**RE: Mercy Hospital – Amendment to Approved Site Plan:
Southerly Driveway Modifications to allow Left Turn
Vicinity 175 Fore River Parkway**

Application ID Number: HTE 10-99900004
CBL: 073-A-001-001

**RE: Mercy Hospital
Southerly Driveway Modifications to Allow Left Turn**

From: Thomas Errico <Thomas.Errico@tylin.com>
To: Jean Fraser <JF@portlandmaine.gov>
Date: 8/18/2010 12:43 PM
Subject: Mercy Hospital Southerly Driveway Modifications
CC: David Margolis-Pineo <DMP@portlandmaine.gov>, Katherine Earley <KAS@port...

PROJECT: FORE RIVER PARKWAY LEFT TURN LANE
SHEET TITLE: ROADWAY IMPROVEMENT PLAN
CLIENT: MERCY HOSPITAL AND REED & REED INC.

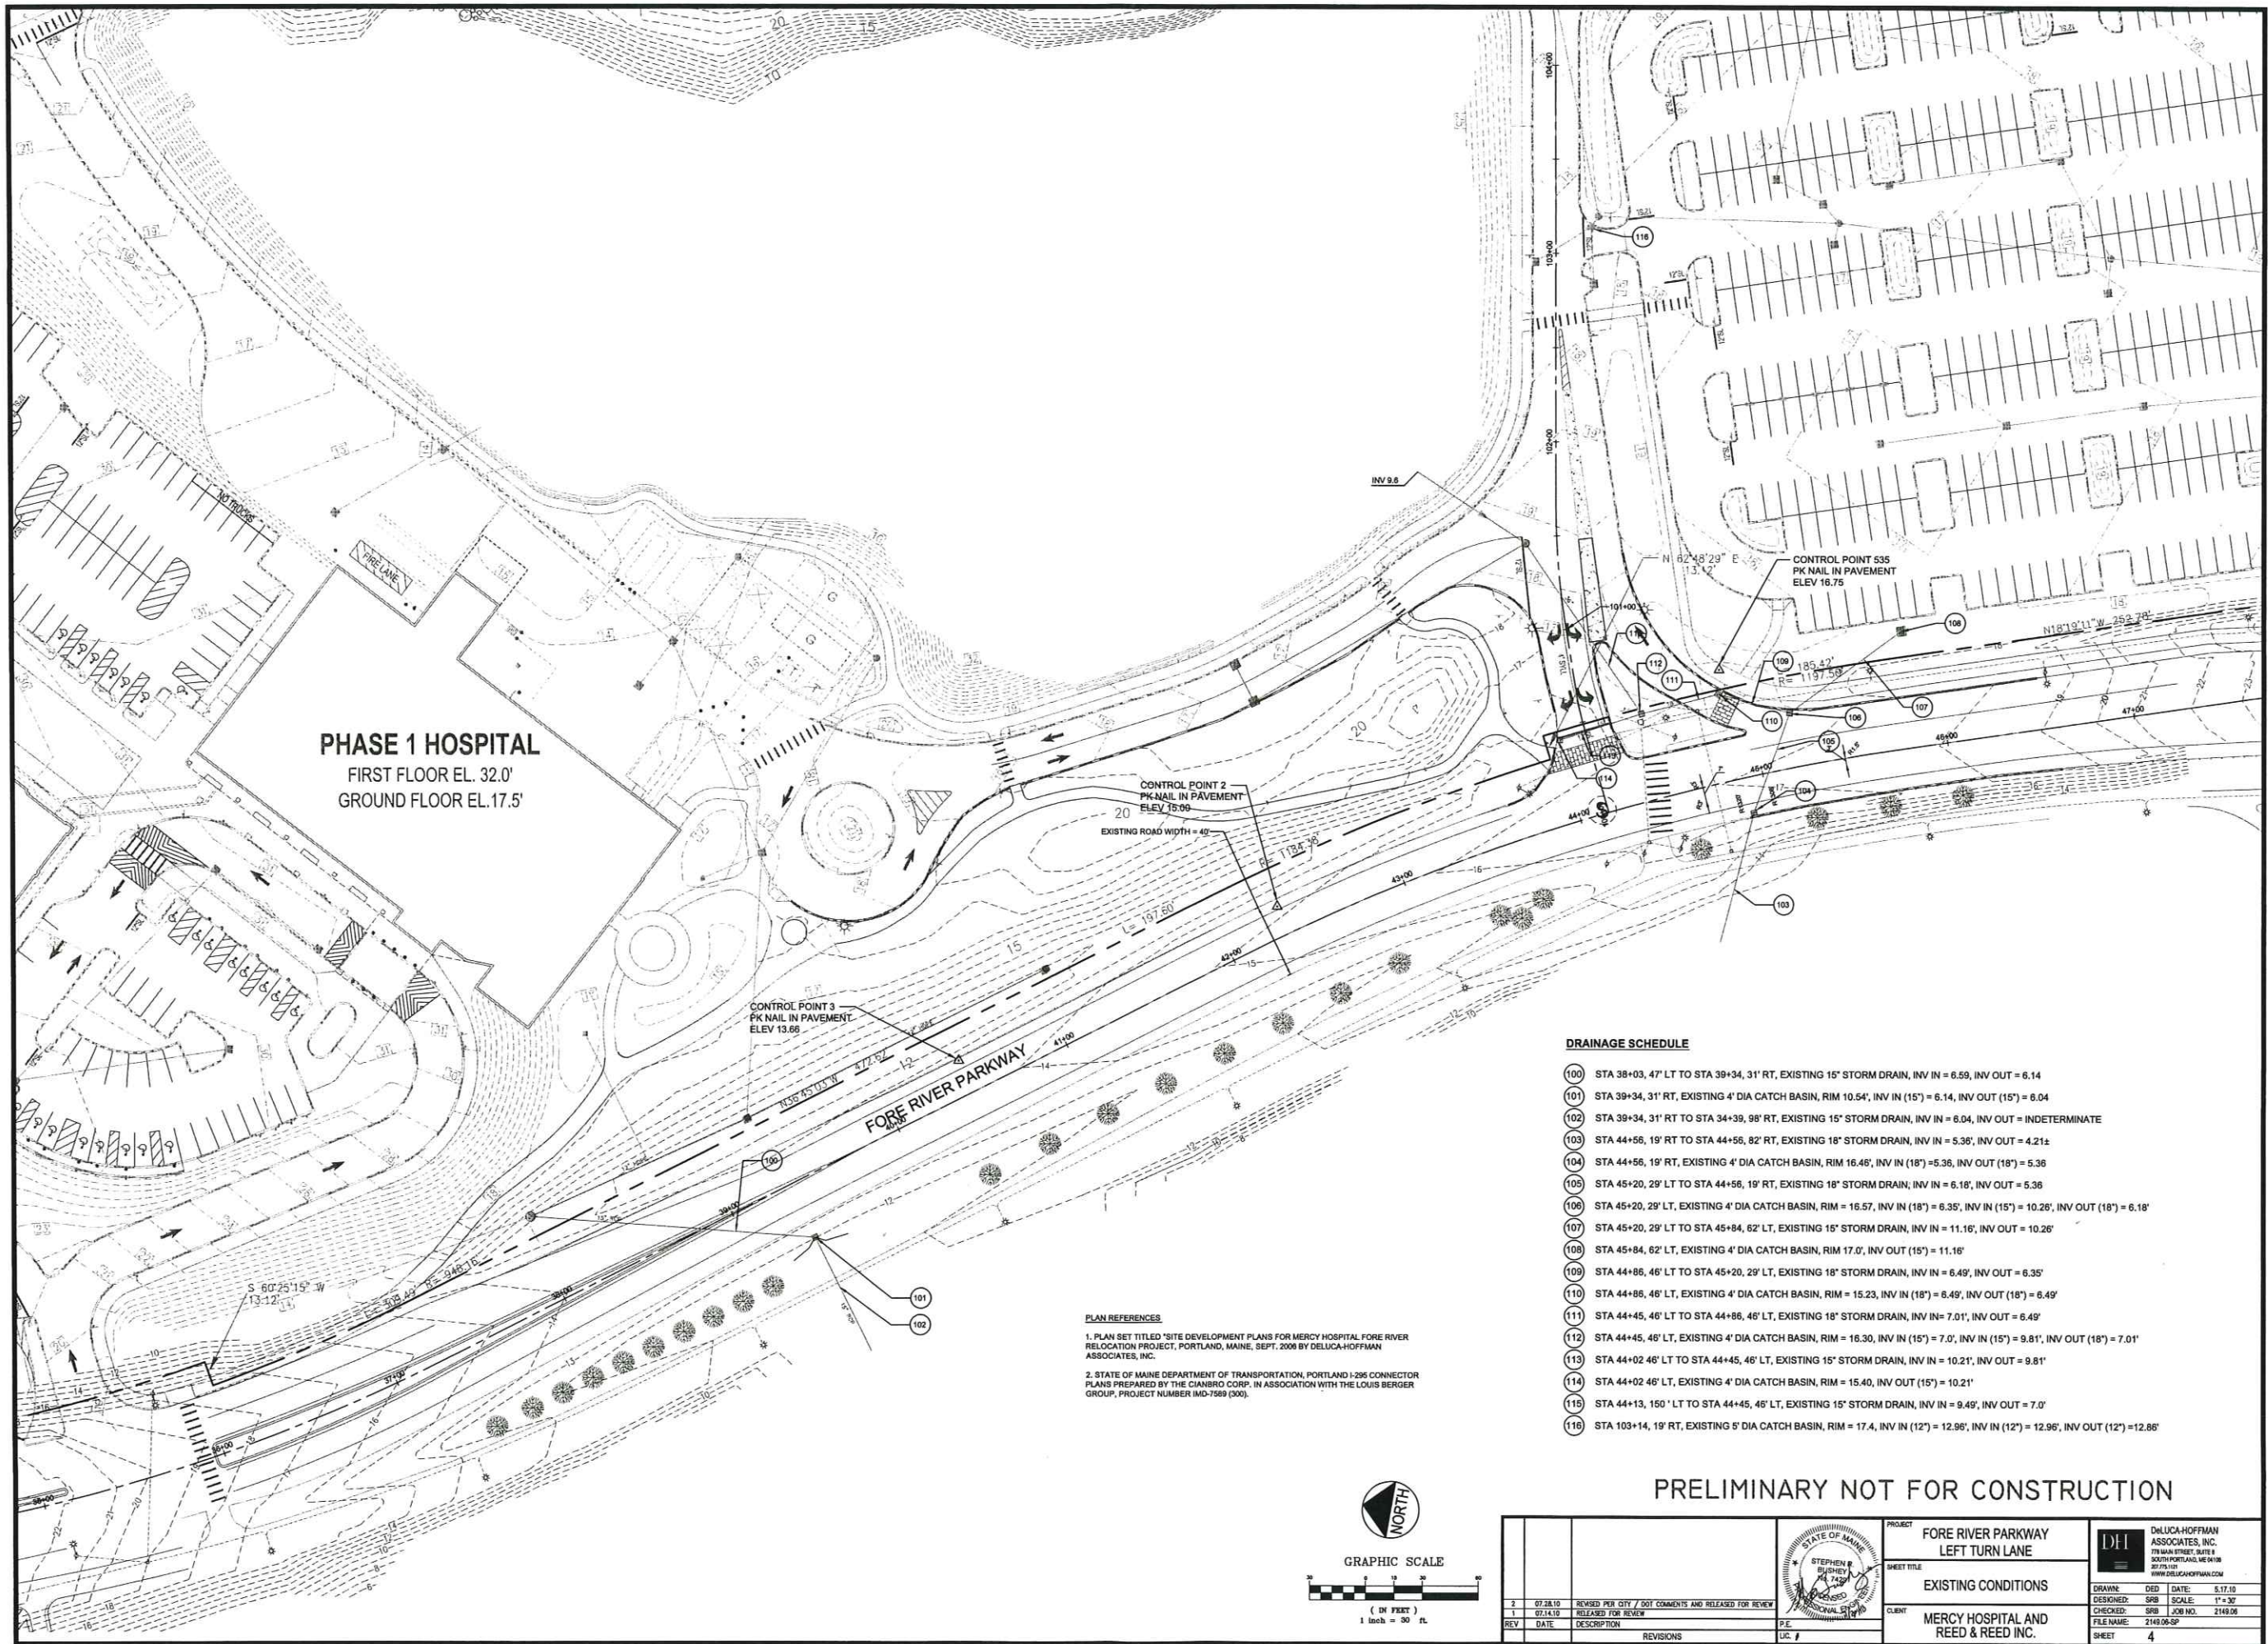
- ii. That the alignment of the sidewalk ramp and detectable warning device on the northeast corner of the subject driveway shall be modified to better meet ADA standards such that the crossing is constructed to be as close to a perpendicular alignment as reasonably practicable. The change shall be reviewed and approved by the Planning Authority prior to construction; and

- iii. That the applicant shall revise the proposals for the modification of the curbing at the entrance to the internal drop-off area to address traffic control, pavement markings, and pedestrian movements as the curb changes have created a very wide open intersection; these changes shall be reviewed and approved by the Planning Authority prior to construction; and

- Condition 3 & 4 – I would rather not have paint delineate the travel area, unless vehicle turning templates indicate such a need. The applicant should provide turning template information that justifies the size of the pavement area.

DRAWN: DEB DATE: 5.17.10
DESIGNED: SRB SCALE: 1" = 30'
CHECKED: SRB JOB NO. 2149.06
FILE NAME: 2149.06-SF
SHEET 6

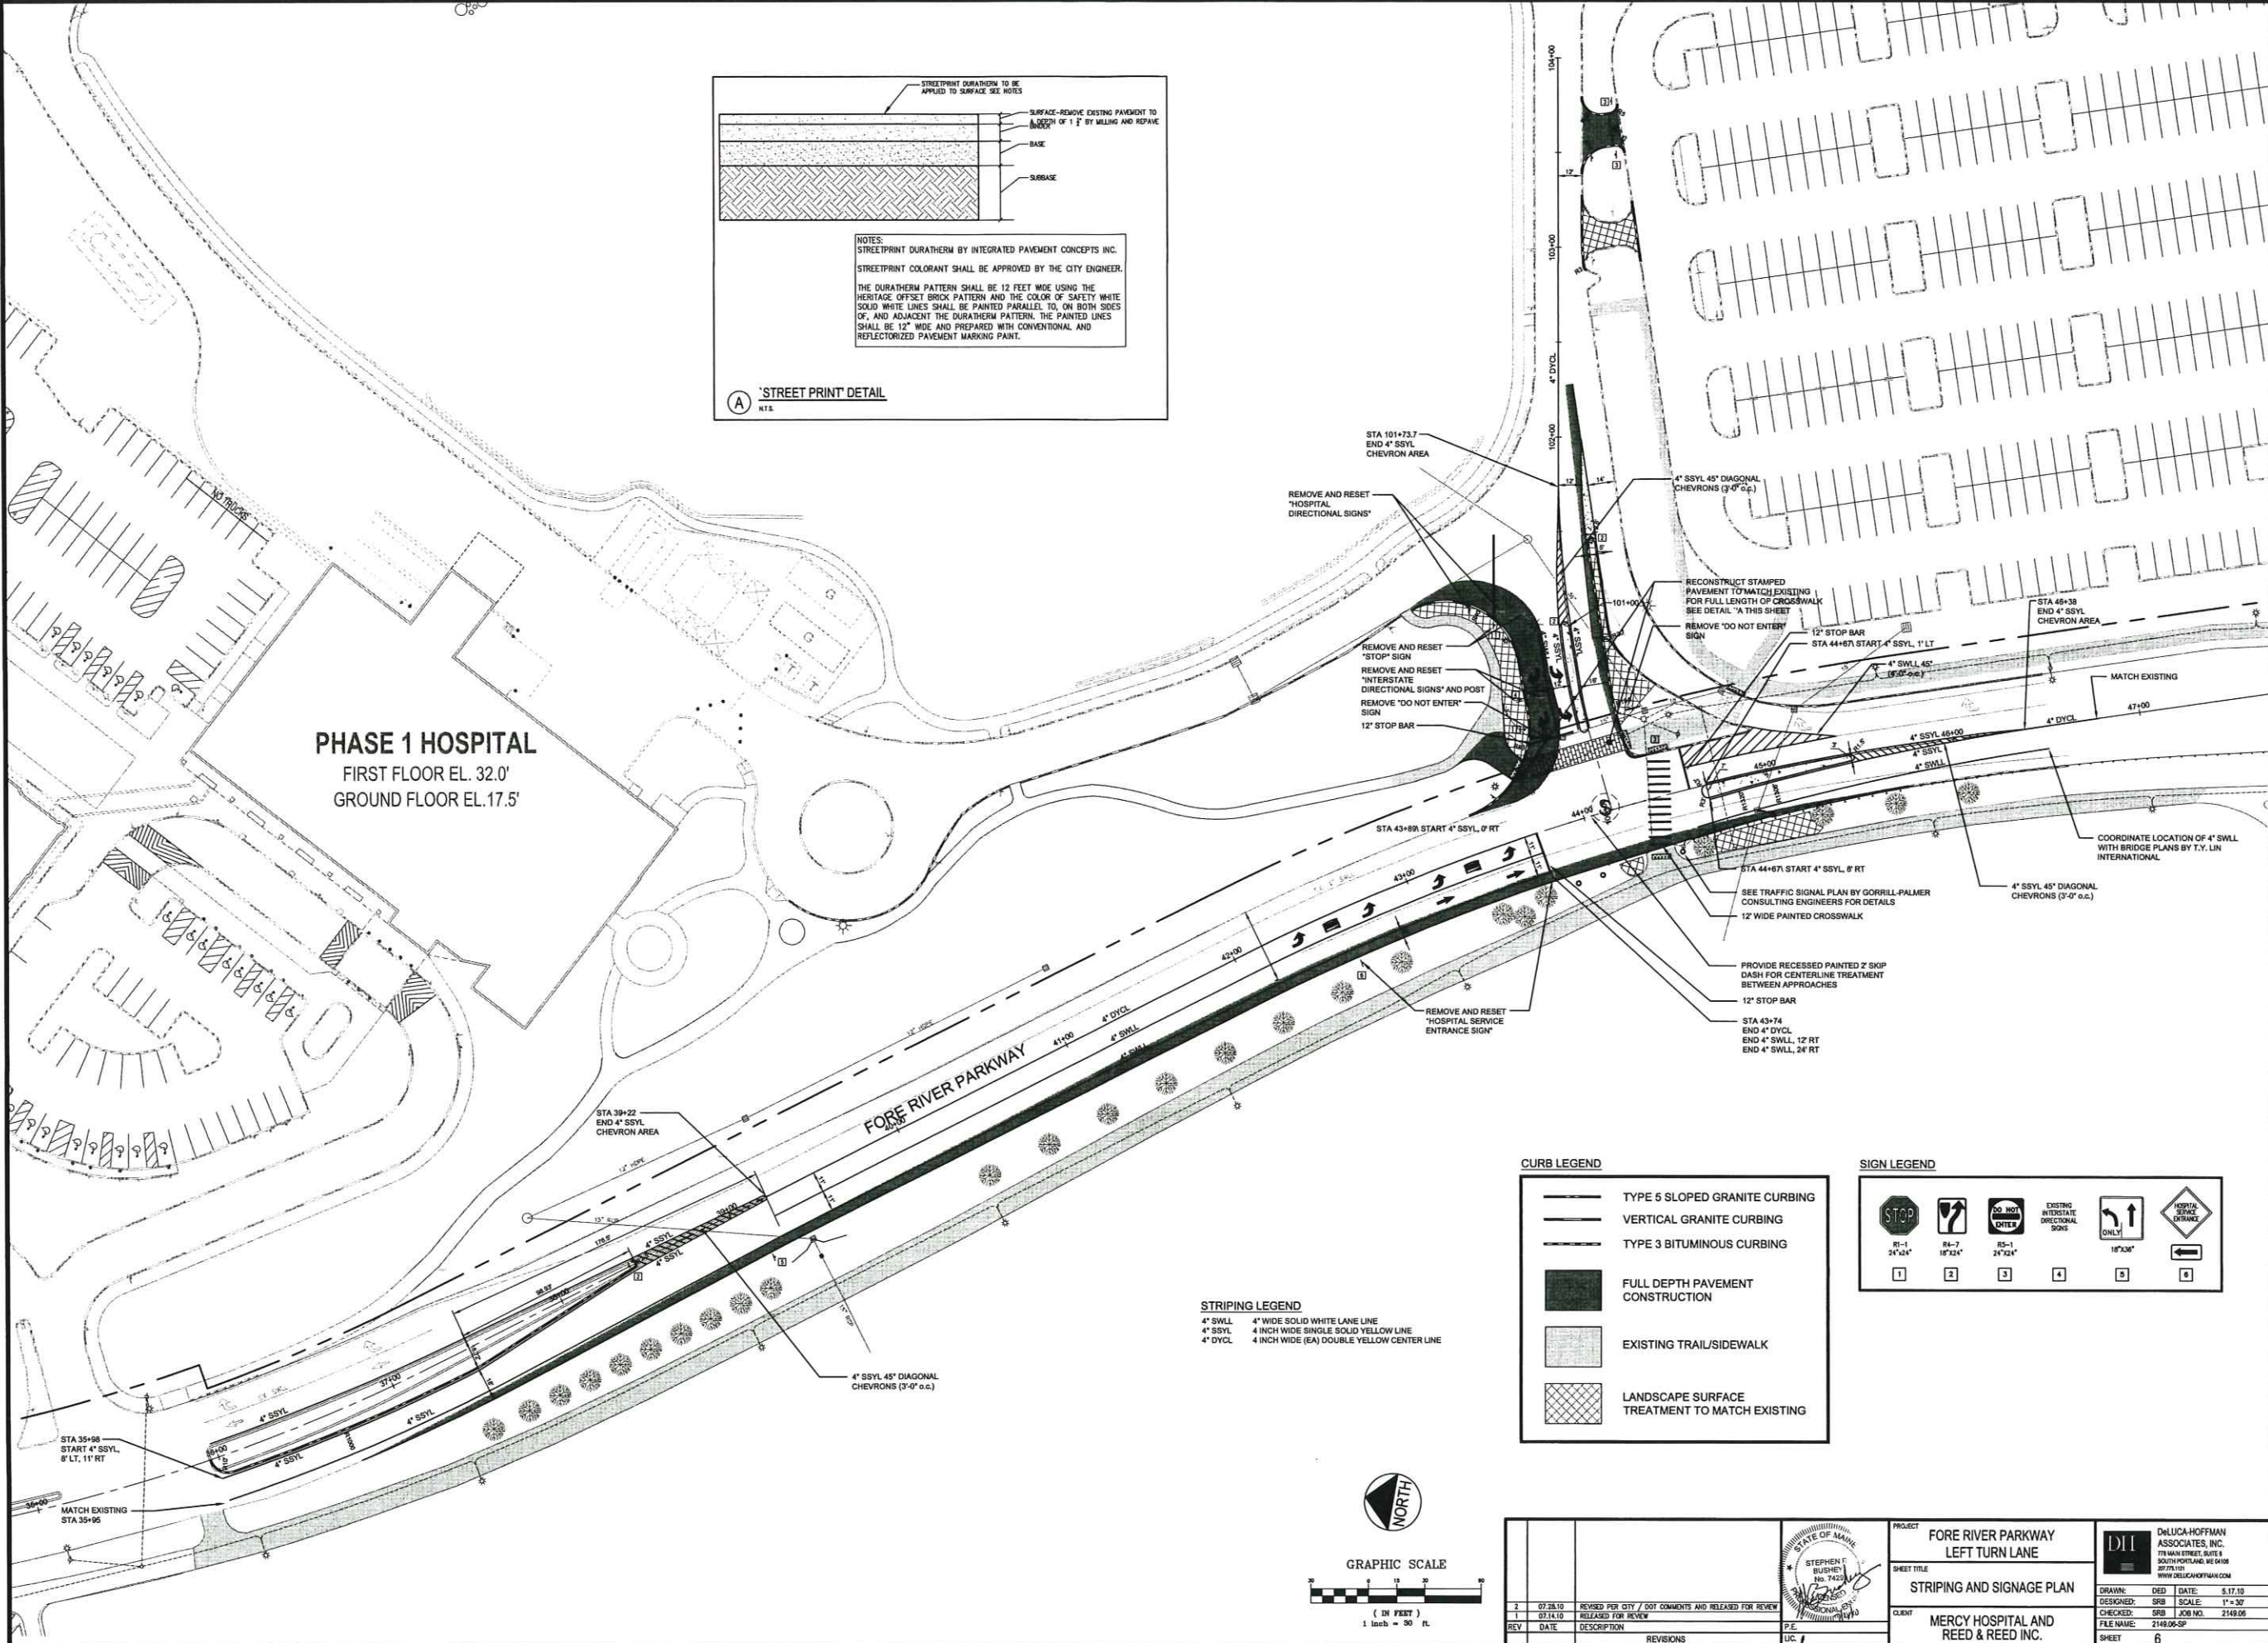
- iv. That a signage and pavement marking plan shall be provided for the internal intersection that shall be reviewed and approved by the Planning Authority prior to installation /construction; and

- vi. That the applicant shall add a note to the plan that states that all existing signs for the hospital that are invalid shall be removed by the applicant with approval from the Planning Authority.

- The plan should include the removal of all existing signs that will no longer be relevant due to the removal of the slip lane. The plan should also include any desired signs for advising motorist of the new Mercy entrance.

Signal Plan

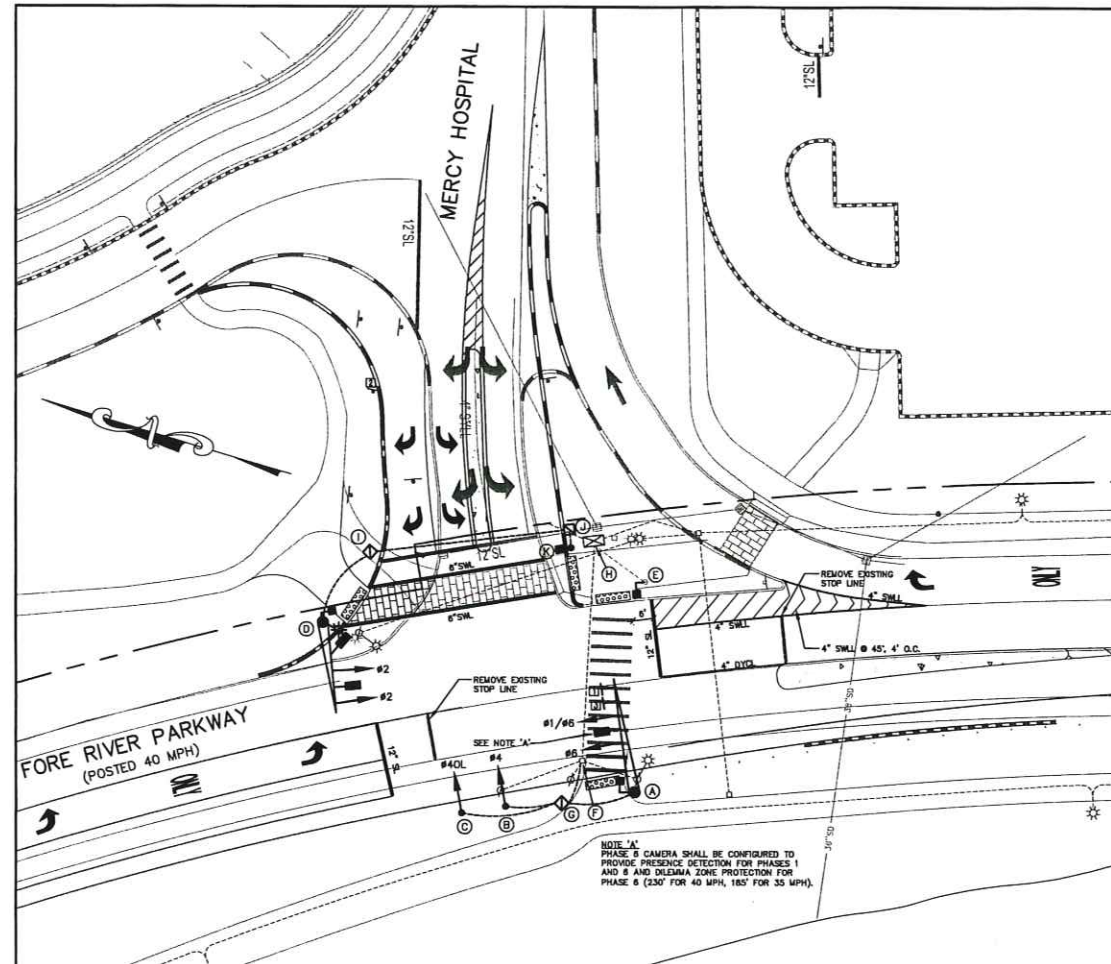
- i. That the applicant shall be responsible for incorporating signal equipment modifications, as necessary, such that it will allow for the subject traffic signal to be coordinated with traffic signals associated with the Veterans Memorial Bridge project; and

- A note shall be added that indicates the traffic signal shall meet City of Portland specifications.
- A note shall be added that notes existing signal equipment not used shall be retained by the City of Portland and shall be delivered to a location as directed by the City.
- Note 10 should indicate that conflicting markings shall be grinded via a method as approved by the City.
- An overlap right-turn phase should be added for right-turns from the Mercy Driveway.
- It should be noted that the City will be requesting a speed limit change to 35MPH. Accordingly, the design should account for this change, as appropriate.
- It is preferred that the Walk time be 7 seconds.
- The proposed entry driveway seems to be excessively wide. The plan indicates a width of approximately 48 feet. An Auto-turn analysis should be provided supporting the proposed width.
